ATTACHMENT 1 - LARGE BREAK LOCA - ECCS
REANALYSIS dtd 10-29-76

ATTACHMENT 2 - CHANGE NO. 47 to Tech
Specs dtd 10-29-76

Large Break LOCA-ECCS
Reanalysis

Surry Power Station
Units No. 1 and 2

FIGURE 3.12-9 INTERIM THIMBLE CELL ROD BOW PENALTY ON $F_{\Delta H}^N$
 SURRY UNITS NO. 1 AND 2

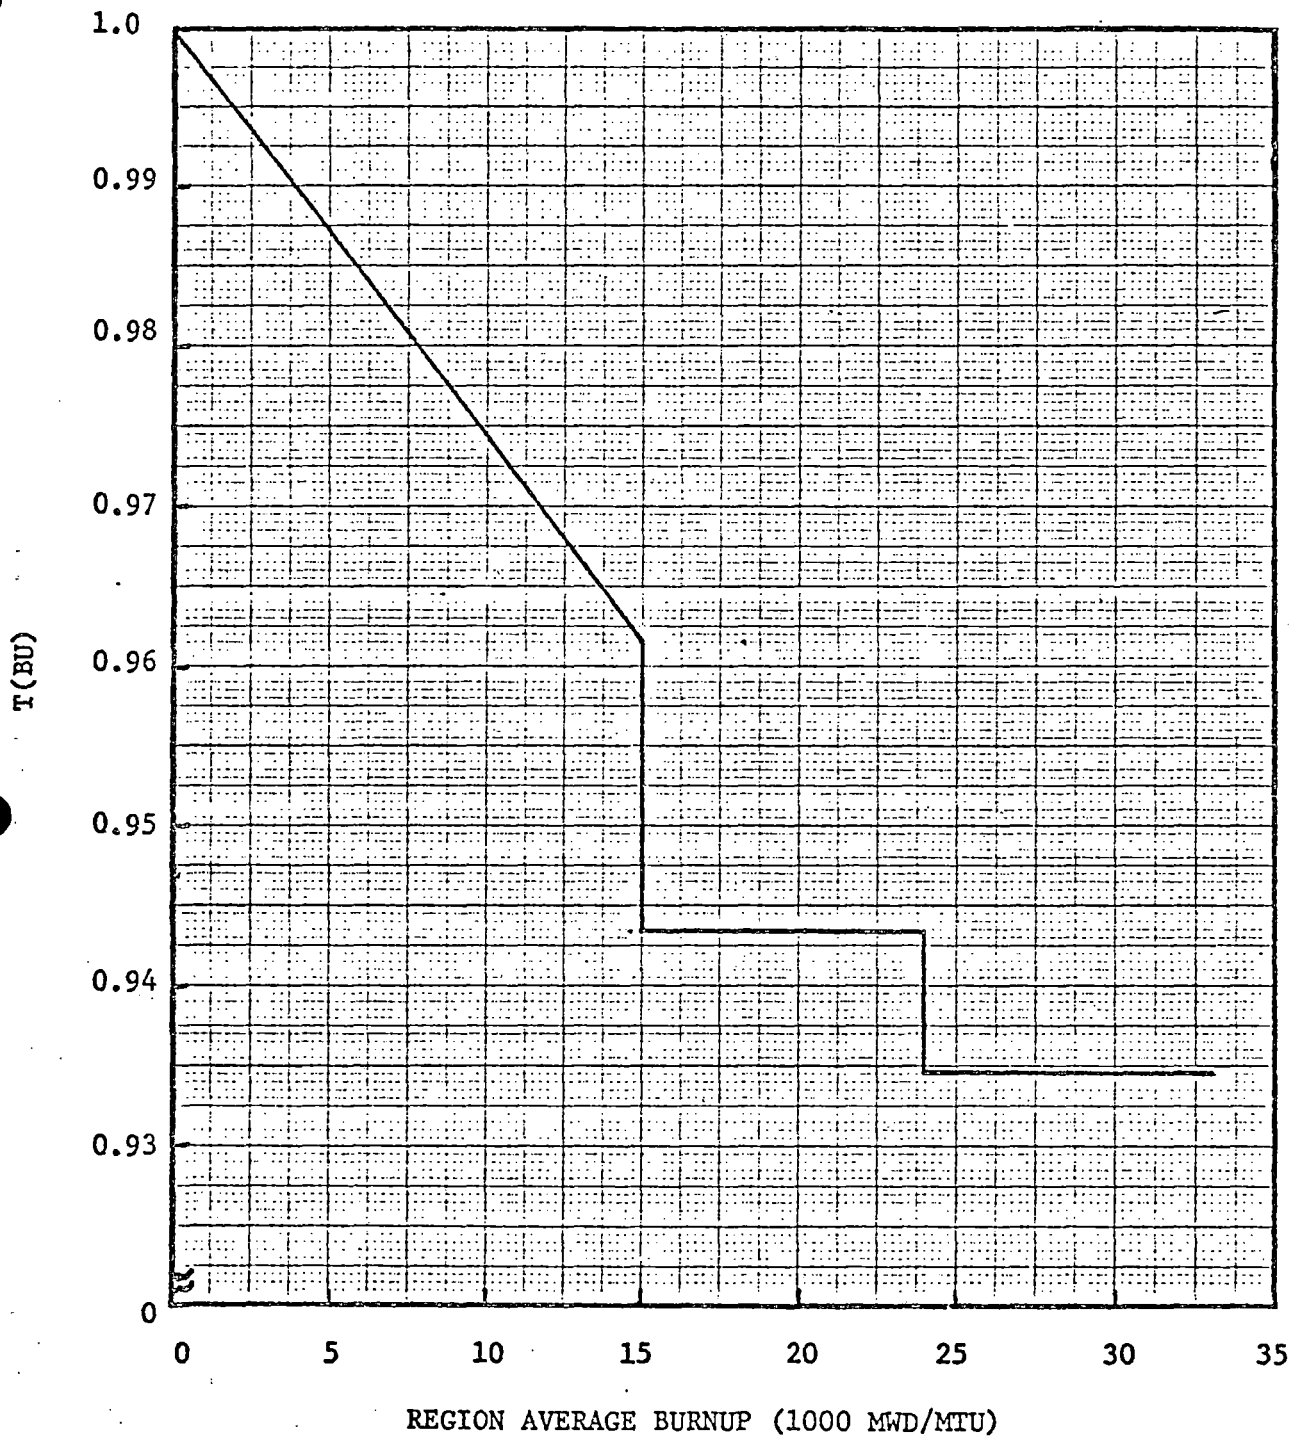
A recent evaluation of DNB test data from experiments of fuel rod bowing in thimble cells has identified that it is appropriate to impose a penalty factor to the accident analyses DNBR results. This evaluation has not been completed, but in order to assure that this effect is accommodated in a conservative manner, an interim thimble cell rod bow penalty for 15 x 15 fuel, T(BU), is applied to the measured values of the enthalpy rise hot channel factor, $F_{\Delta N}^N$. It is anticipated that the values of this penalty will change after the evaluation of the test data has been completed.

where P is the fraction of rated power at which the core is operating, K(Z) is the function given in Figure 3.12-8, Z is the core height location of F_Q , and T(BU) is the interim thimble cell rod bow penalty on $F_{\Delta H}^N$ given in TS Figure 3.12-9.
